Midway City Council 18 May 2021 Regular Meeting

Resolution 2021-13 / Street Cross-Sections

Subject: Memo Regarding Midway City Standard Roadway Widths

A RESOLUTION BY THE MIDWAY CITY COUNCIL ADOPTING AN UPDATED STANDARD SPECIFICATIONS AND DRAWINGS FOR THE CITY OF MIDWAY

LOCAL STREET CROSS SECTION #1 **COMMERCIAL & BUSINESS**

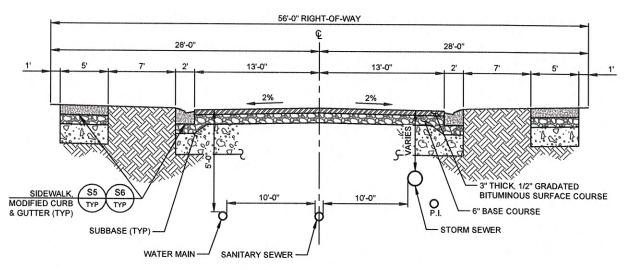
- 1. Local Street Cross Section #1 for Commercial Business
 - a. It is proposed to leave the asphalt cross section as shown. This will accommodate parking and allowing vehicles to open doors without causing issues for cars driving on the street.
